Access Compliance Report

Public Rights-of-Way

(Curb Ramps)

Intersection ID: 27427	Main Street: TILLEY MORRIS RD	Cross Street: DEERFIELD CREEK DR	Location: S
ADA ID: 0180AB980AB7	Ramp Type: BlendTrans1	Initial Pass/Fail: Fail	Overall Compliance: No
		Severity Score: 30

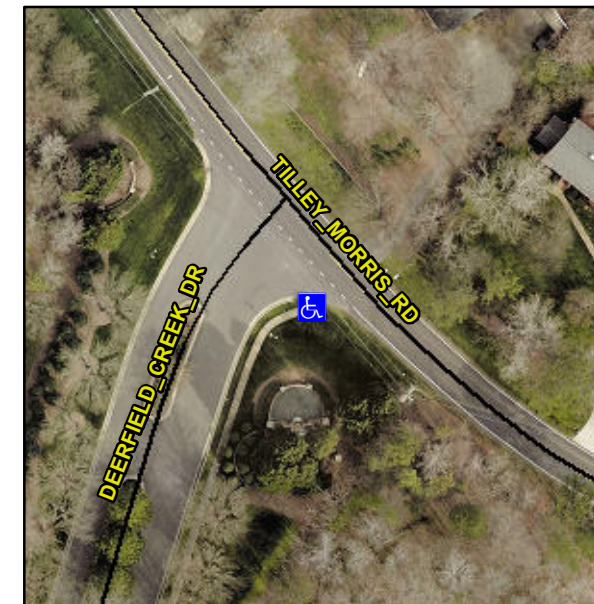
R304.5.1, R304.5.3

Compliance	Description	Data	Compliance	Description	Data
N/A	Ramp Length (in)	42.0	Yes	BlendTrans Slope (%)	4.0
No	Ramp Width (in)	33.0	No	BlendTrans XSlope (%)	5.1
N/A	Flare Type LT	N/A	N/A	Flare Type RT	N/A
N/A	Flare Slope LT (%)	N/A	N/A	Flare Slope RT (%)	N/A
N/A	Flare Traversable LT?	N/A	N/A	Flare Traversable RT?	N/A
N/A	Landing Length (in)	N/A	N/A	DWS Provided?	N/A
N/A	Landing Width (in)	N/A	N/A	DWS Contrast?	N/A
N/A	Landing Slope (%)	N/A	N/A	DWS Length (in)	N/A
N/A	Landing X Slope (%)	N/A	N/A	DWS Full Width?	N/A
N/A	Landing Curb? (Y/N)	N/A	N/A	DWS Offset (in)	N/A
N/A	Shared Landing?	N/A			
N/A	Gutter Ponding?	N/A	N/A	Gutter Slope (%)	N/A
N/A	Gutter Lip Ht (in)	N/A	N/A	Gutter X Slope (%)	N/A
N/A	Painted X Walk1?	No	N/A	Painted X Walk2?	N/A
	X Walk 1 Direction	To NE		X Walk 2 Direction	N/A
	X Walk 1 Width (in)	N/A		X Walk 2 Width (in)	N/A
	X Walk 1 Slope (%)	6.5		X Walk 2 Slope (%)	N/A
	X Walk 1 X Slope (%)	3.6		X Walk 2 X Slope (%)	N/A

Remove & Replace Curb Ramp With Two New Directional Ramps or Equivalent.
